SUBJECT: Proposed Specification: 6500200 Vehicular Traffic Signal Assemblies.

VEHICULAR TRAFFIC SIGNAL ASSEMBLIES (REV 5-14-21)

ARTICLE 650-2 is deleted and the following substituted:

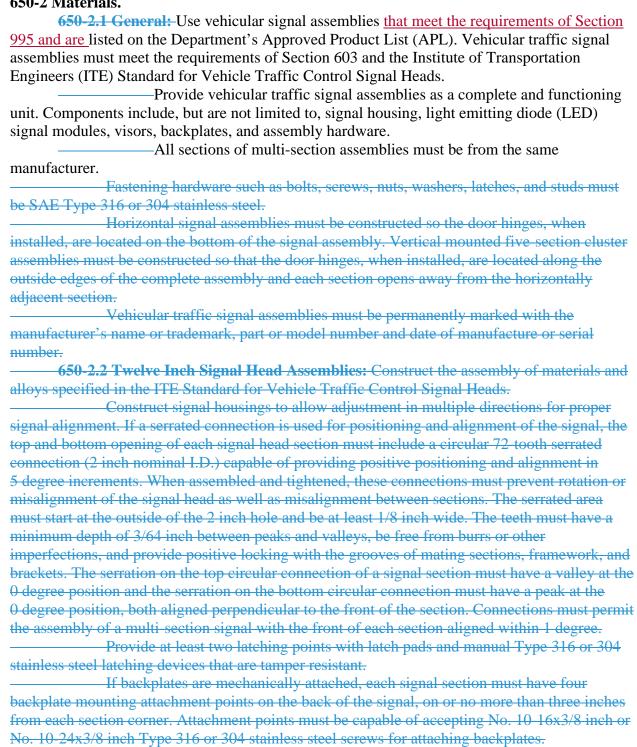
This change was proposed by Derek Vollmer from the Traffic Engineering and Operations Office to move the materials sections from Division II to Division III. This proposed specification revision is associated with the changes to Section 995.

650-2 Materials.

Tri-stud washers, when utilized to secure signal sections, must have a minimum
thickness of 0.090 inches. For five-section cluster assemblies, tri-stud washers used to attach the
top signal section to the multi-signal bracket and the multi-signal bracket to the bottom four
signal sections must have a minimum thickness of 3/8 inches. When fastened together, washer
distortion is not allowed.
